STATE OF WASHINGTON
DEPARTMENT OF ECOLOGY
PO Box 47775 • Olympia, Washington 98504-7775 • 360-407-6300
Call 711 for Washington Relay Service • Persons with a speech disability can call 877-833-6341

Re: Opinion on Proposed Cleanup of the following Site:

- **Property Address:** 608 North First Street, Tacoma, Pierce County, WA 98403
- **Facility / Site Name:** Morrells Dry Cleaners
- **Facility/Site ID:** 18489568
- **Cleanup Site ID.:** 386
- **VCP Project No.:** SW1039

On June 7, 2021, Ecology received a Site wide RI/FS Work Plan (the Report³). You requested that Ecology concur with the proposed data gap evaluation to complete the remedial investigation.

FIGURE NO. 9

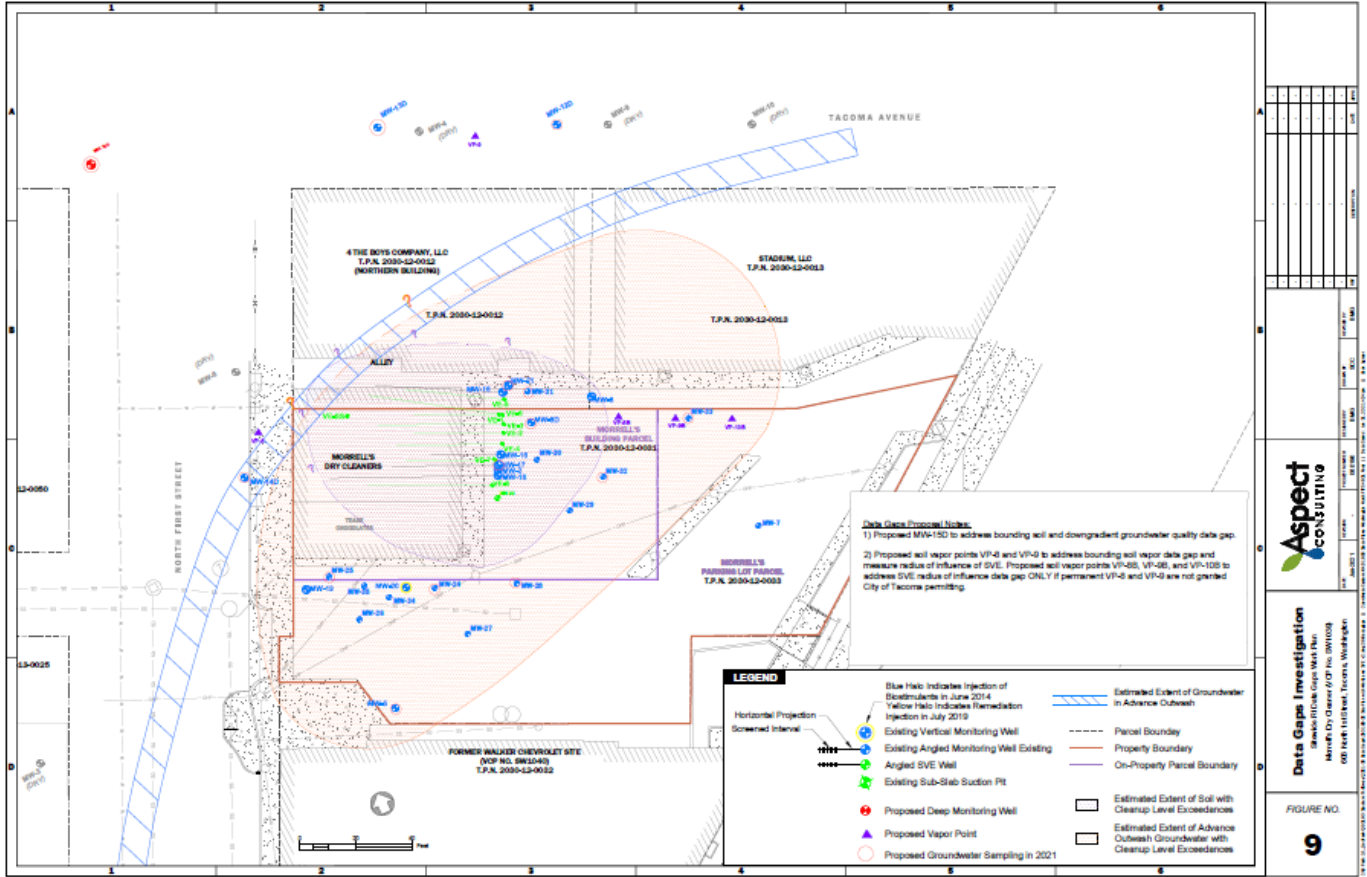
Air: To address the remaining data gaps for the air pathway Aspect proposed two potential options: advance two permanent vapor points (VP-8 and VP-9) within the City of Tacoma right-of-way along Tacoma Avenue and North First Street (pending permit approval) or install temporary vapor points within the Morell's parking lot (**Enclosure B - Aspect Figure 9**).

Air Pathway: Ecology does not concur that the proposed approach will sufficiently delineate the air pathway. Additional sampling and evaluation is needed.

Groundwater: Groundwater beneath the Site is impacted in both the shallow (advance outwash) and deeper (Olympia bed interglacial deposits) water bearing zones. To address the remaining groundwater characterization data gaps in the deeper water water-bearing zone, Aspect proposes to advance monitoring well MW-15D within the intersection of Tacoma Avenue and North First Street to a total depth of 140 feet below ground surface (**Enclosure B - Aspect Figure 9**).

Deeper water water-bearing zone: Ecology concurs with the approach to install MW-15D within the deeper water bearing zone and understands the limitations posed by utilities in the immediate area. As proposed, Ecology concurs with the approach to continue monitoring at wells MW-8D, MW-12D, MW-13D, MW-14D, and MW-15D.

Shallow water water-bearing zone: Ecology does not concur that the nature and extent of groundwater contamination has been fully defined in the shallow-water bearing zone. Additional monitoring wells may be needed at the following locations:

- hydraulically cross/up-gradient from MW-33 as close as practicable to the estimated extent of groundwater in the advanced outwash.
- hydraulically up-gradient from monitoring wells MW-27/28.
- hydraulically down-gradient from MW-25 as close as practicable to the estimated extent of groundwater in the advanced outwash.

FIGURE NO. **5**

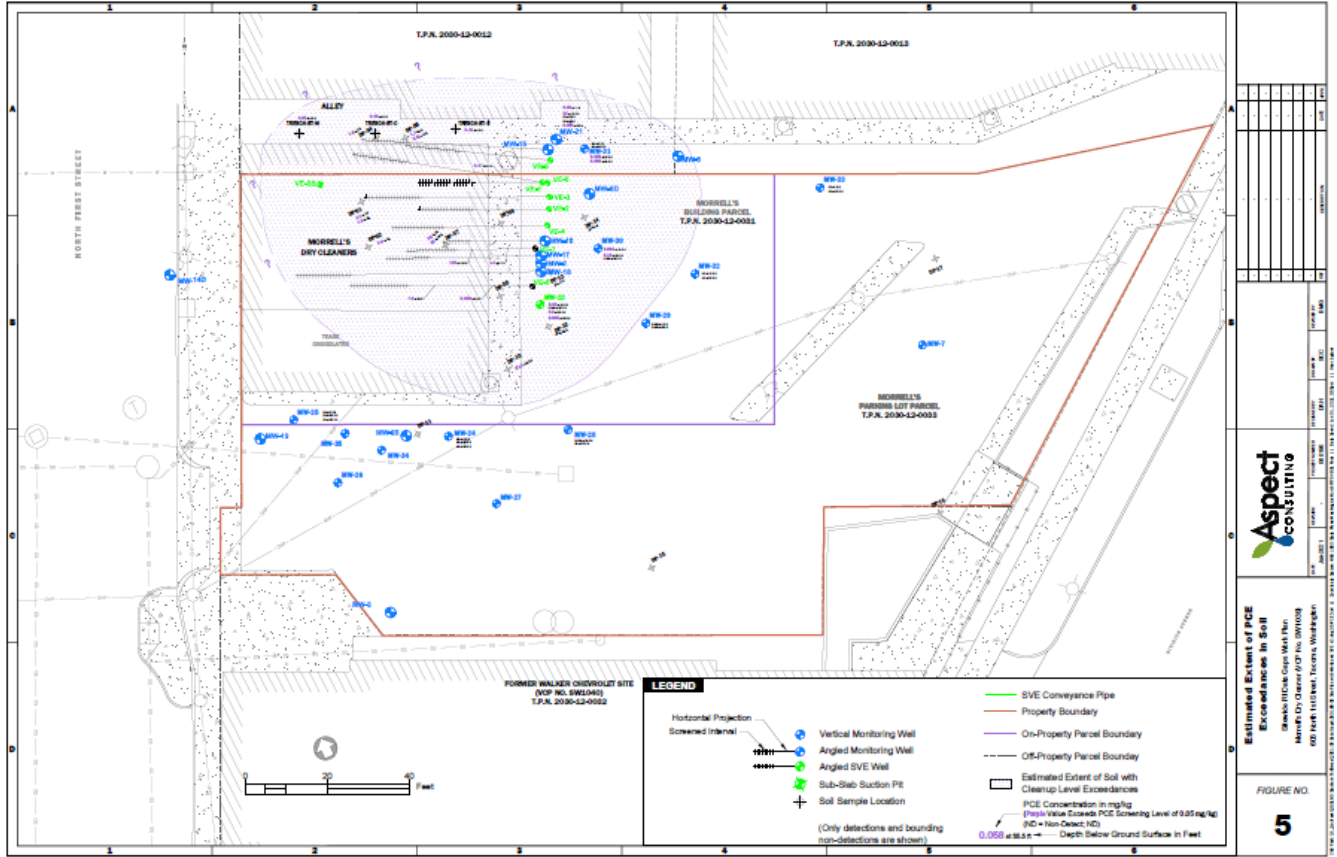
Soil: To address the remaining soil characterization data gaps Aspect proposes to advance monitoring well MW-15D within the intersection of Tacoma Avenue and North First Street to a total depth of 140 feet below ground surface (**Enclosure B - Aspect Figure 5**).

Ecology concurs with the approach to collect additional soil characterization data at MW-15D. Ecology recommends that additional soil samples be collected at recommended monitoring wells to be installed with the shallow water bearing zone.

Ecology presumes a reasonable worst case scenario that PCE contamination extends laterally into Tacoma Avenue and North First Street and vertically to depths greater than 60 feet bgs.
